BRIEF DESCRIPTION OF REQUEST
Amend an approved DRB Site Plan for Building Permit to modify the site layout.

ADMINISTRATIVE AMENDMENT TO SITE PLAN FOR BUILDING PERMIT

CARLISLE CROSSING
2100 CARLISLE BLVD NE
ALBUQUERQUE, NEW MEXICO

Sheet Title:
Landscape Plan

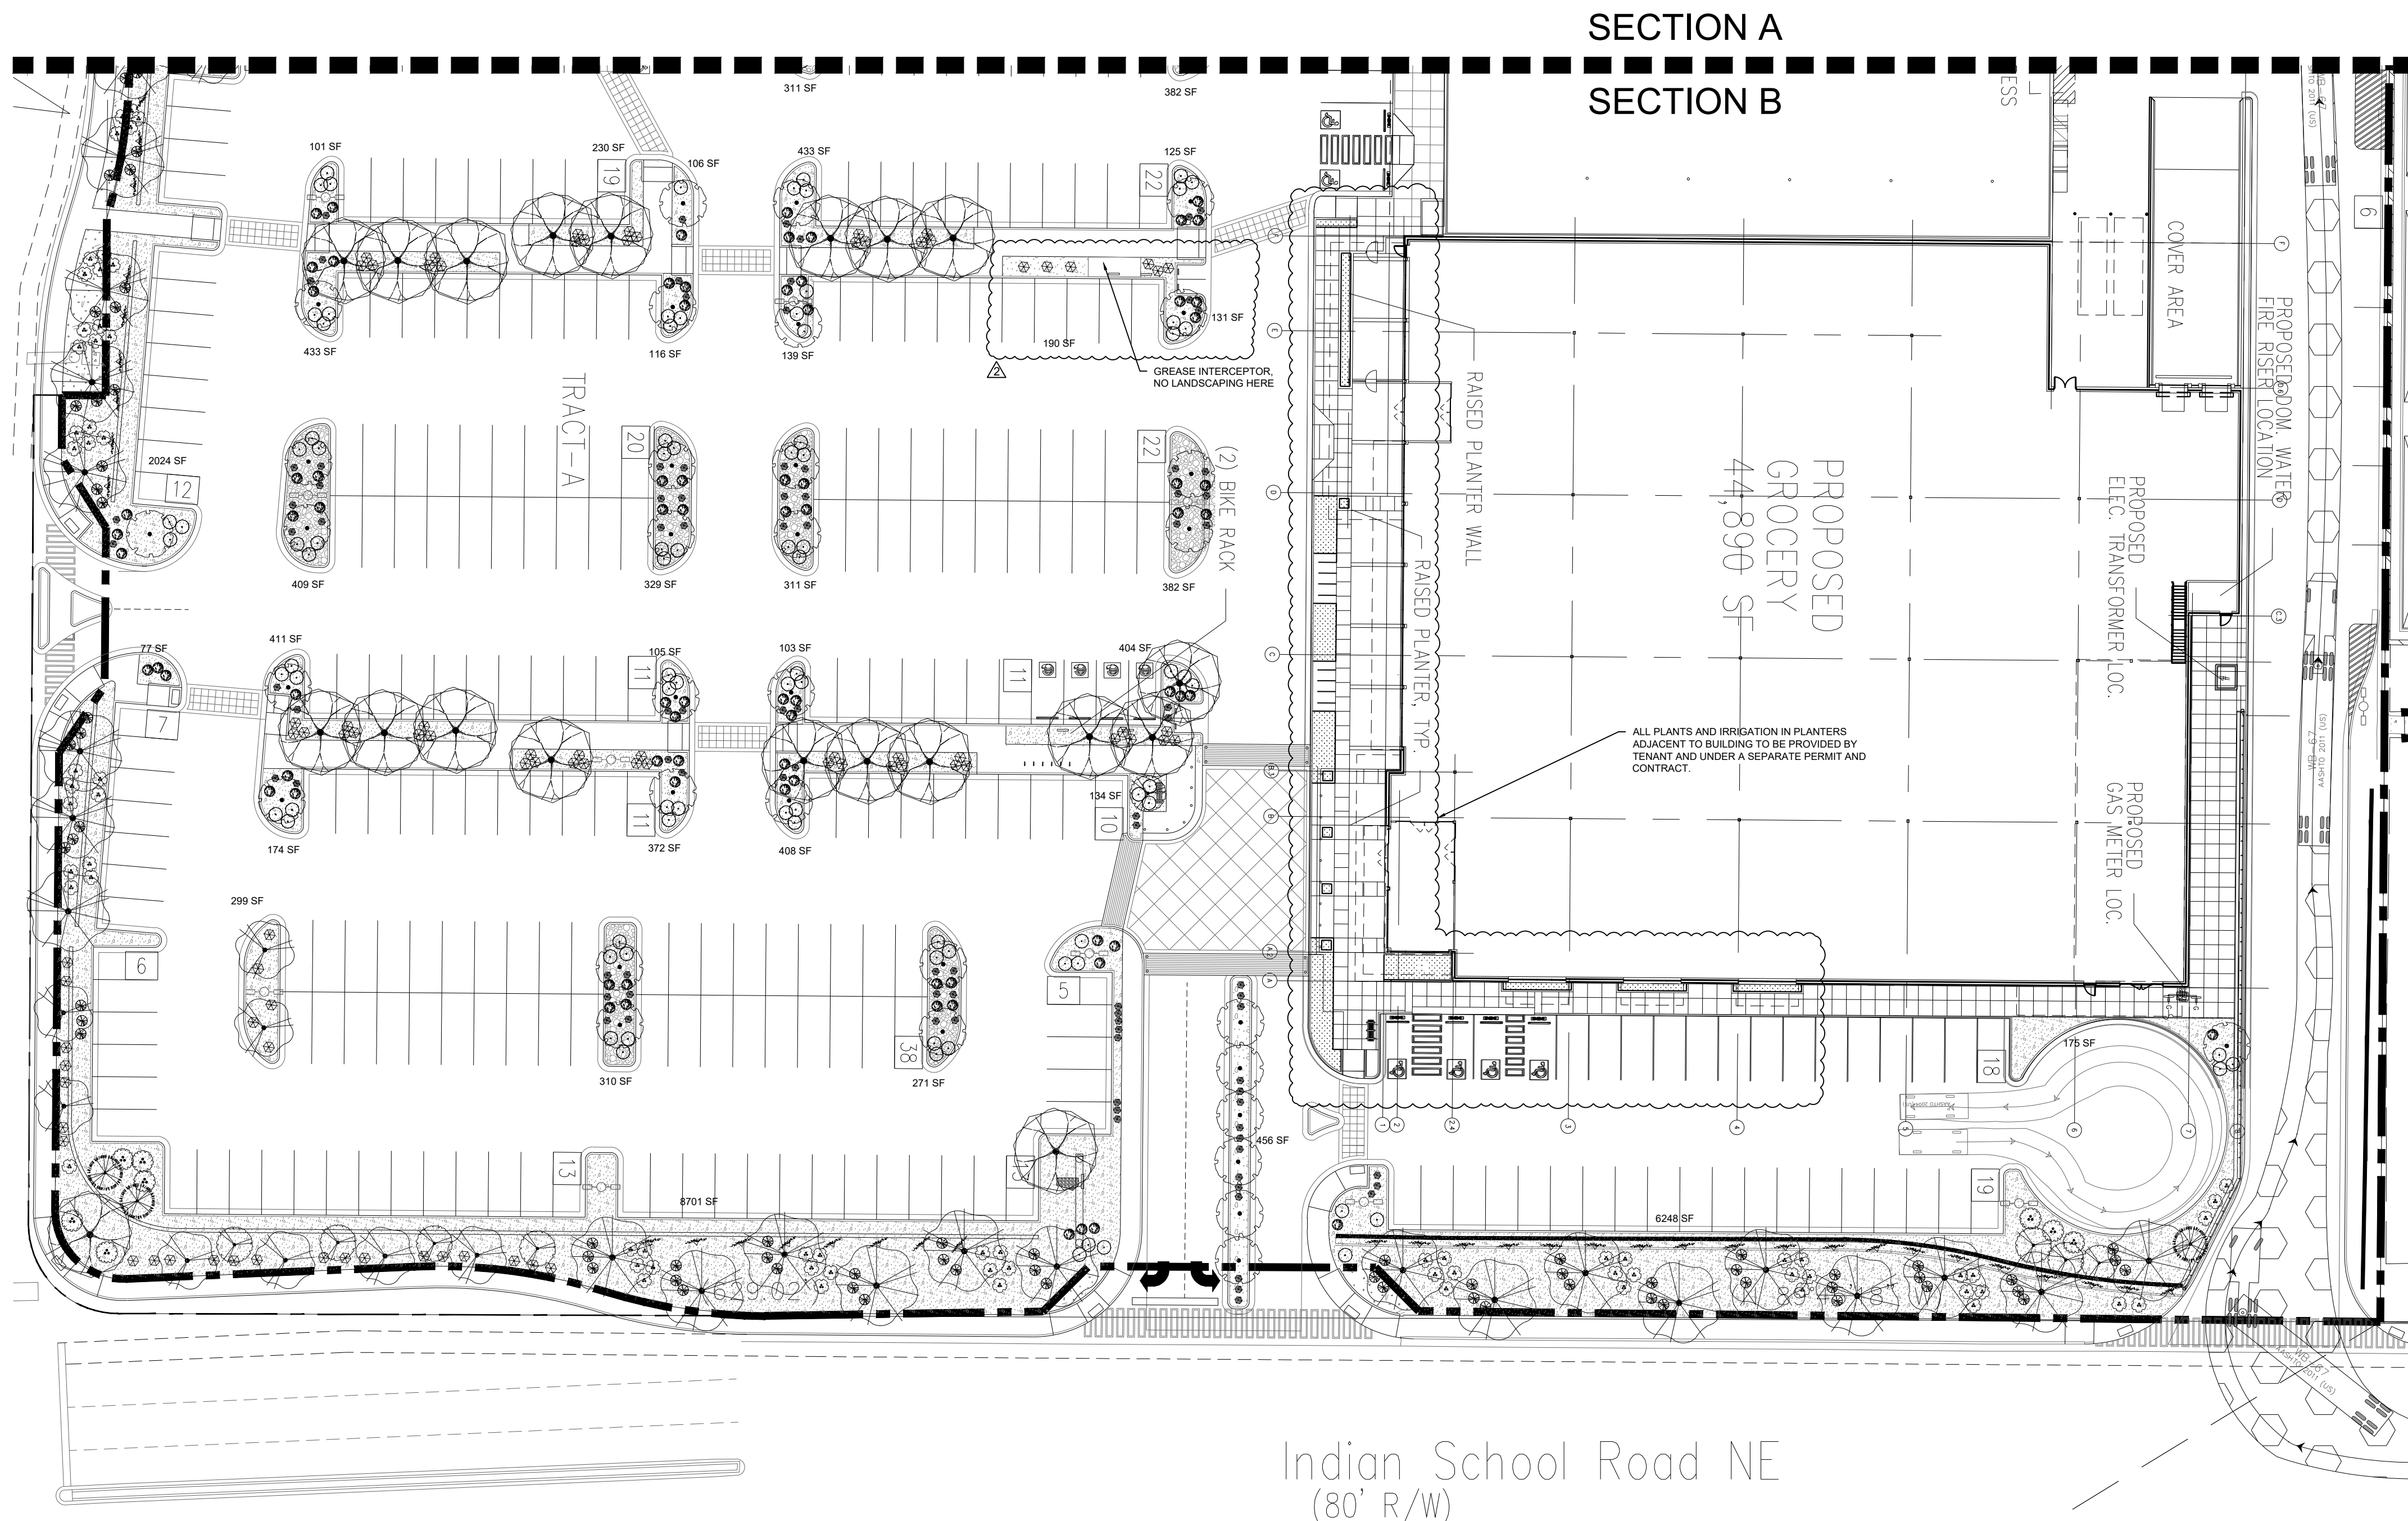
Landscaping Plan:

1. A Landscaping Plan has been modified to accommodate the changes to the Site Plan. All changes meet the IDO and the DPM standards. We have not created a deficiency in the landscaping requirements and that is demonstrated on the Landscaping Plan.
